BUILDING COMPLETION REPORT.

I beg to report the building work on plot No. 15 Sheet A15Bundy Quarter owned by Mr. Kamamal Chellaram

AMENDED
PLAN
SHOWING PROPOSED BUILDING ON PLOT NO. 15 SHEET NO. A15.
BUNDER QUARTER.
SCALE 8=1

AMENDED PLAN
OF BUILDING ON PLOT NO 15 SHEET NO A-15.
BUNDER QUARTER.
SCALE 8"=1"

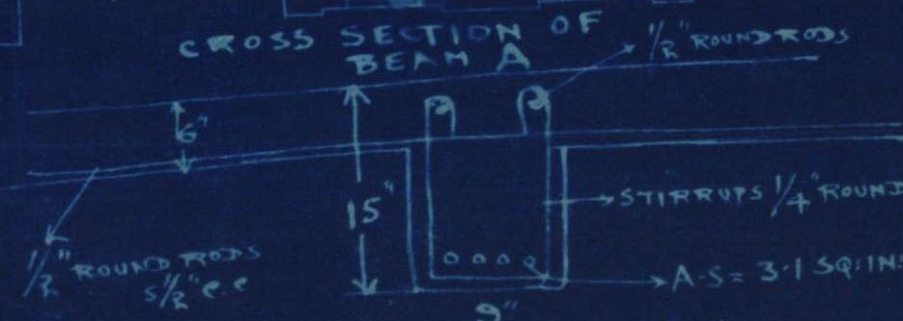
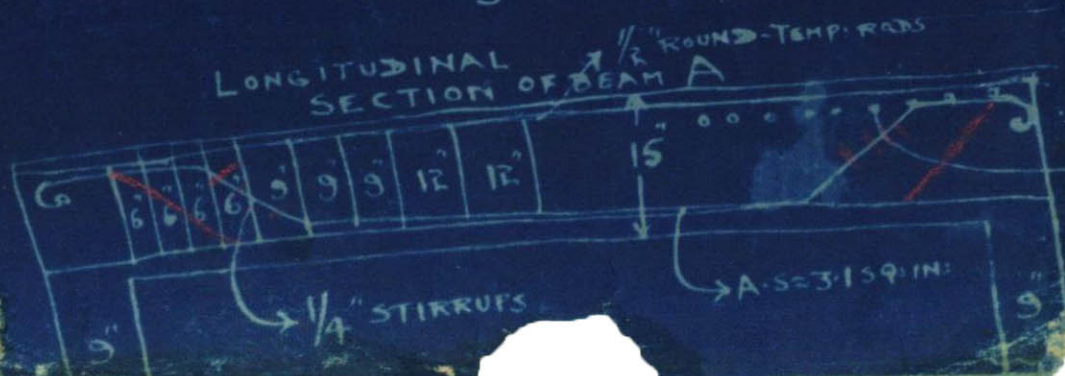
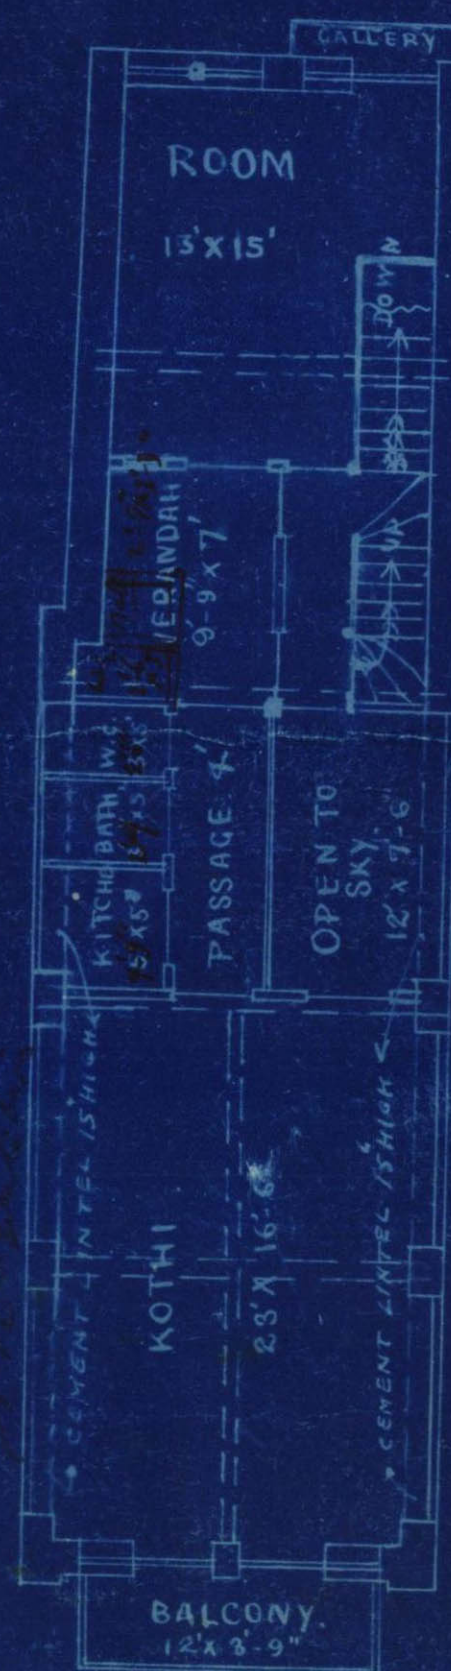
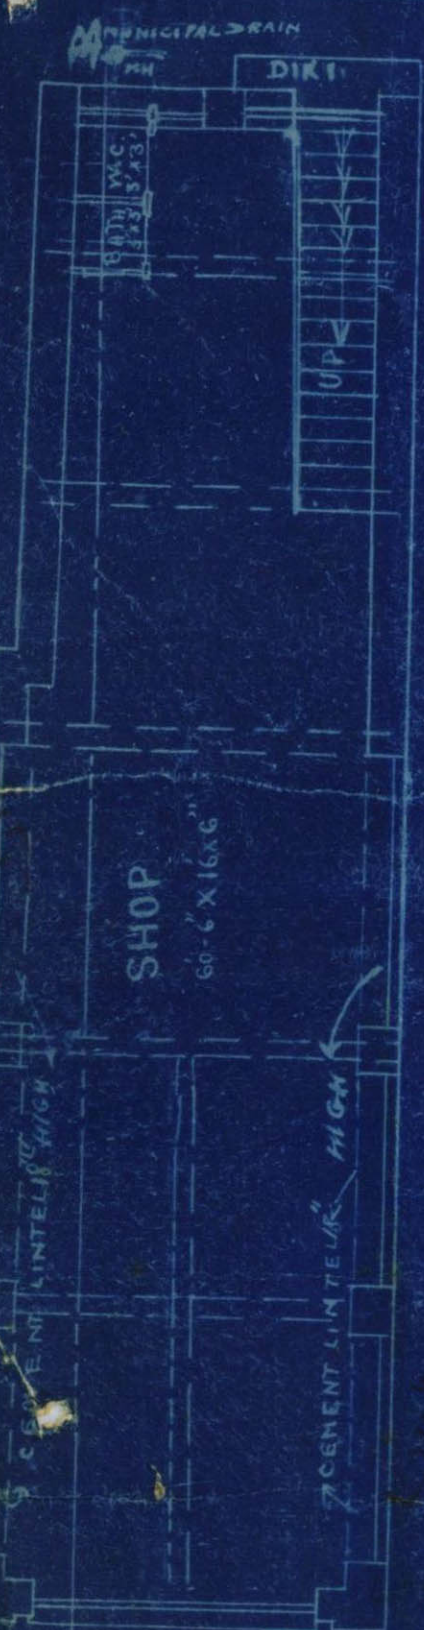
Roof of the upper storey is quite
different from that shown in the plans approved

*The owner has ~~submitted~~ submitted amended
plan adding one more floor.
uptill now the construction is in
accordance with the plan.*

*Plans must be fully
dimensioned*

6" curb wall is not
represented the ball
must be represented & seen
with the pillars & being.

open shed
cannot be allowed
after the above requirements
are complied with

- (1) $3\frac{1}{2}$ Cement wall is not yet founded & the wall must be reinforced & secured with the pillars & ^{this is in line} ~~main~~.
- (2) Open shed. Could only be allowed after the above requirements are complied with.
- (3) One w.c. is allowed with open tap.
- (4)
- (5)
- (6)
- (7)
- (8)
- (9)

- (1) ~~531~~⁴ Cement wall is not yet provided and the wall must be reinforced & secured with
- (2) the pillars & beams ^{with iron ties}
- (3) Open Shed ^{only} be allowed after the above requirements are complied with.
- (4) one W.C is allowed ^{with open top}
- (5)
- (6)
- (7)
- (8)
- (9)

Plans are corrected by the architect as per above

L.M.A.
Corrected according to
our objection: 28/4/27.
